May 19, 2022  
IBI Reference No.:137021

**Attention: Brian Gregatti**  
**Development Services, Development Engineer**

**Re: Response to Town Comments**  
**OPA No.: 1616.56**  
**Your Memorandum Dated: April 11, 2022**  
**Applicant: Melanie Hare, Urban Strategies Inc.**  
**Location: 588, 550, 530 Kerr Street and 131, 171 Speers Road**

#### ***Functional Servicing & Stormwater Management Report, dated January 31, 2022, prepared by IBI Group;***

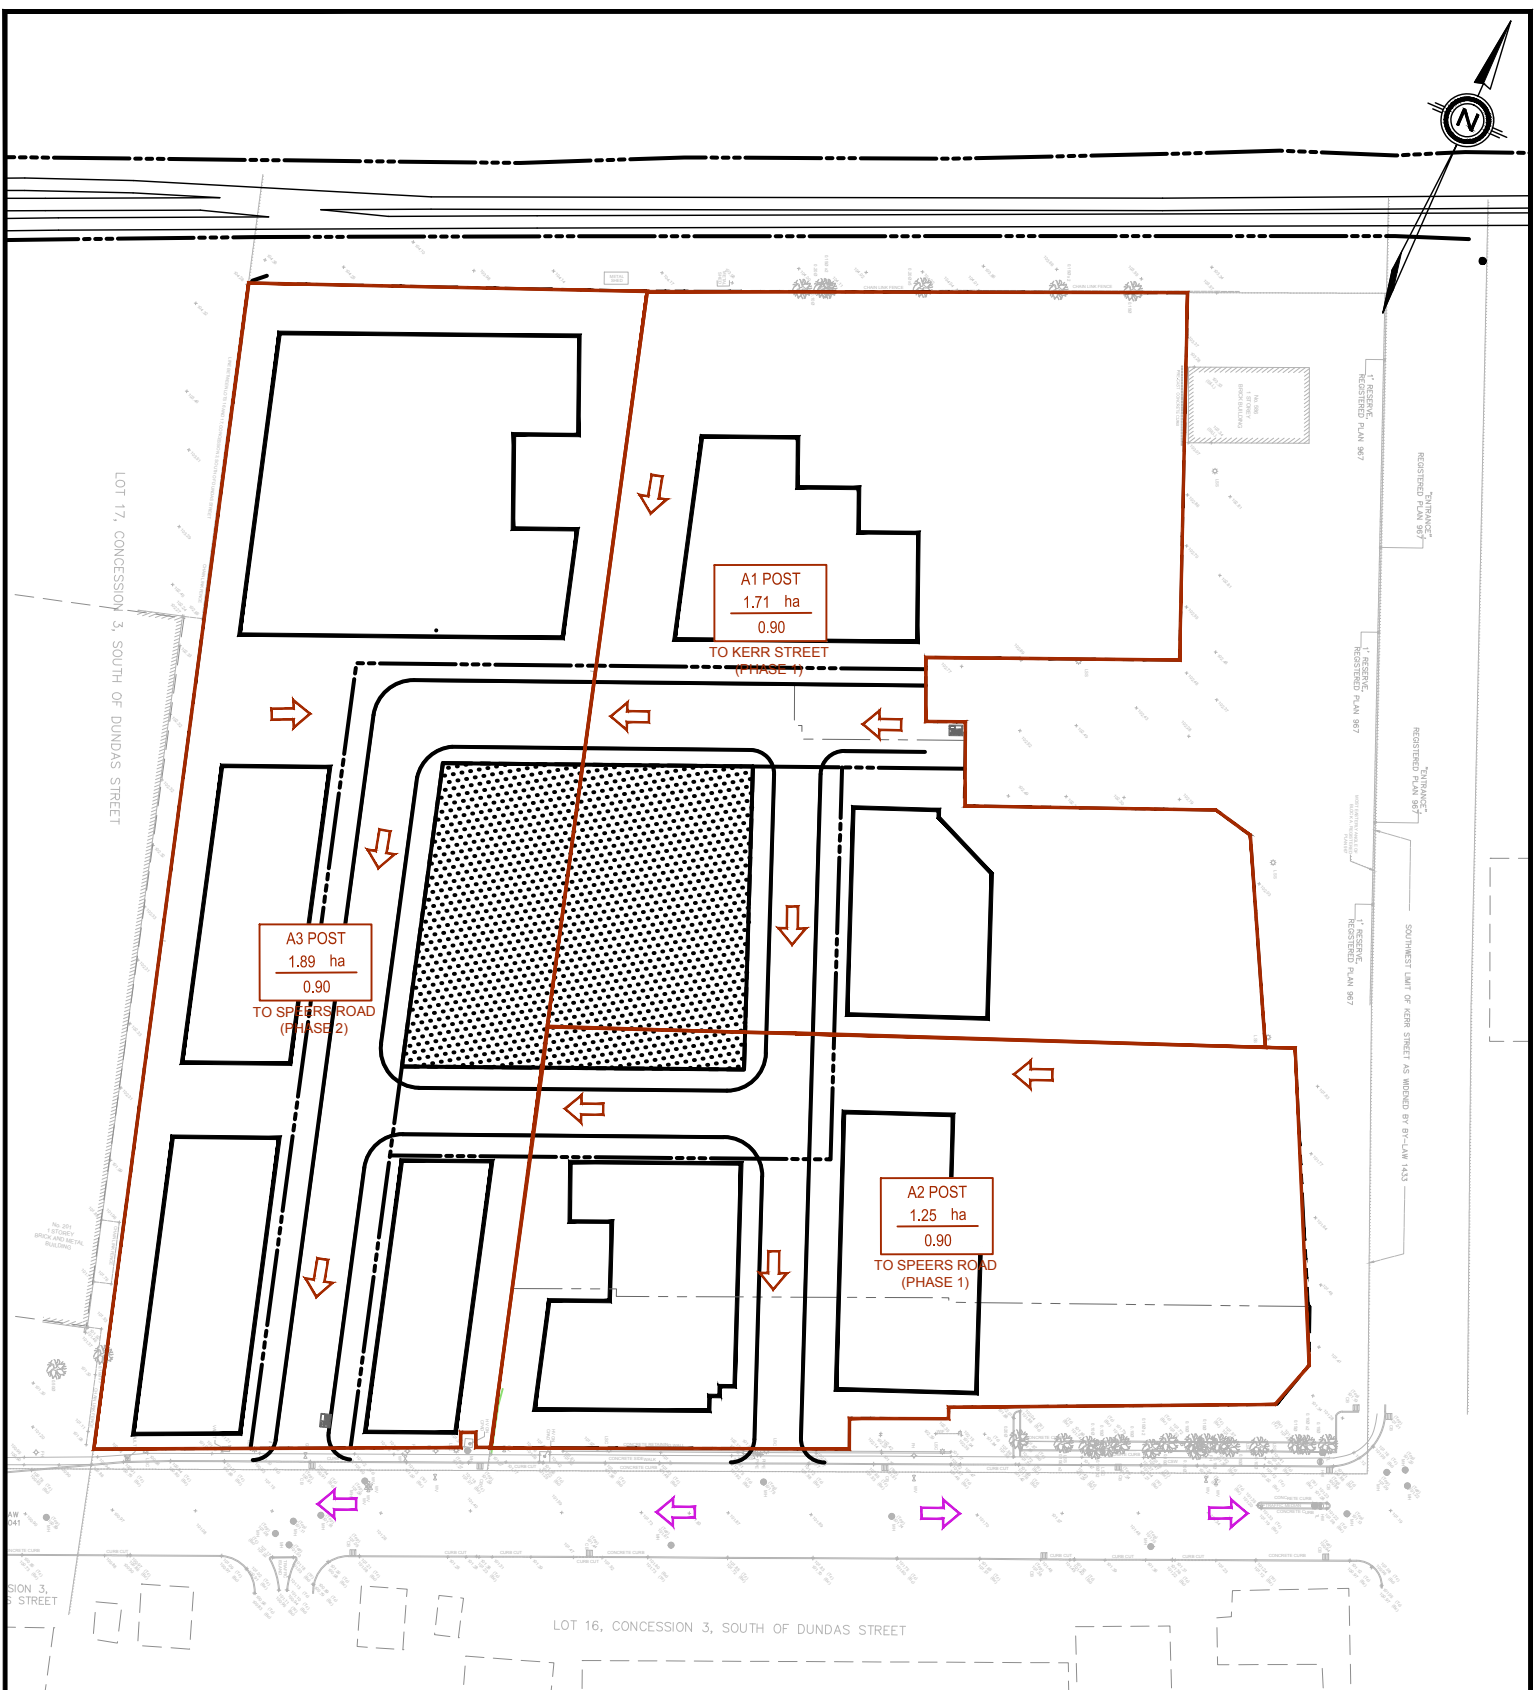
- a. *The SWM report appears to lump the subject site into one catchment area and does not specify the proposed outlet(s) under pre and post development conditions. Please confirm whether flows within the subject site under existing drainage conditions split between Kerr and Speers Road. Please provide additional discussion related existing and proposed drainage patterns within the SWM report.*

- d. *The FSR does not provide pre and post development drainage area plans in support of the SWM strategy for the subject development. Please provide these plans and clearly illustrate minor and major drainage pathways under both pre and post development conditions.*

**Additional discussion of pre-development drainage patterns and catchment areas has been included in Section 4.1 and Figure DAP-1. Additional discussion of post-development drainage has been included in Section 4.4 and Figure DAP-2.**

**Pre- and post-development drainage area plans have been included in Appendix B.**
